PALMER WOODS SUBDIVISION, PHASE III

This is a request for a one-year extension of a previously approved 48-lot subdivision. The subdivision is located on the West side of Oakhill Drive, ½ mile± North of Moffett Road.

DETAIL SITE PLAN

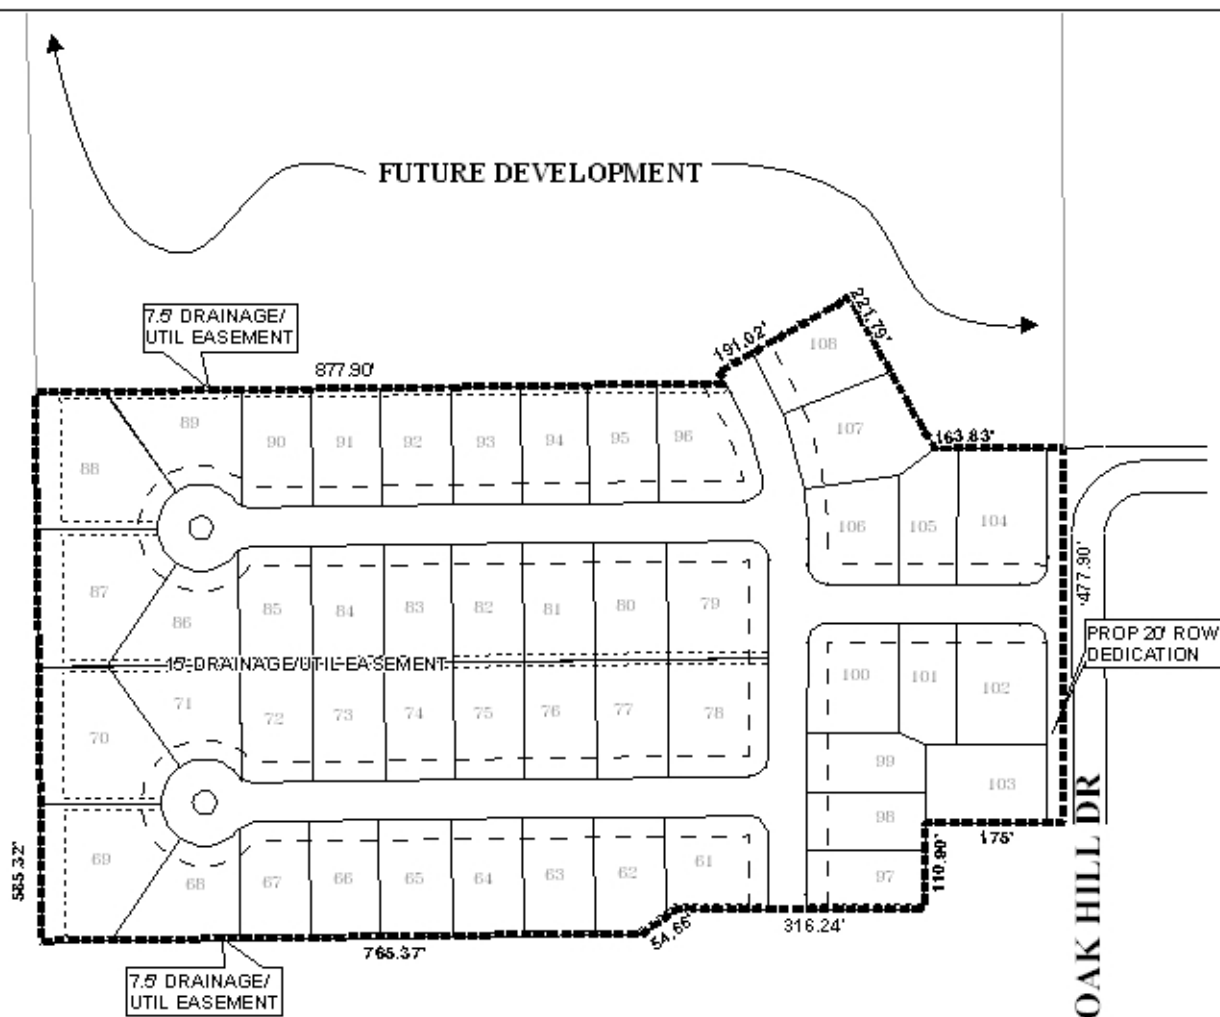
- 1) the dedication of sufficient right-of-way to provide 50-feet from the centerline of Oak Hill Drive;
- 2) the placement of a note on the Final Plat stating that Lot 103 is allowed one curb cut to Oak Hill Drive, with the size, location and design to be approved by Mobile County Engineering;

- 3) the placement of a note on the Final Plat stating that Lots 102 and 104 are denied direct access to Oak Hill Drive;
- 4) the placement of the minimum building setback lines along Oak Hill Drive on Lots 102, 103 & 104;

- 5) provision of the minimum requirements of Section V.D.2;
- 6) provision of a certification letter from a licensed engineer to the Planning Section of Urban Development, certifying that the stormwater detention, drainage facilities, and release rate comply with the City of Mobile stormwater and flood control ordinances, prior to the signing and recording of the Final Plat;

- 7) placement of a note on the plat stating that any lots which are developed commercially and adjoin residentially developed property must provide a buffer, in compliance with Section V.A.7. of the Subdivision Regulations; and

- 8) labeling of all lots with size in square feet, or placement of a table on the plat containing the lot size information.

- 9) modification of the cul-de-sacs to 120' diameters to meet the 2003 International Fire Code requirements as per the April 3, 2008 amendment to the Subdivision Regulations.
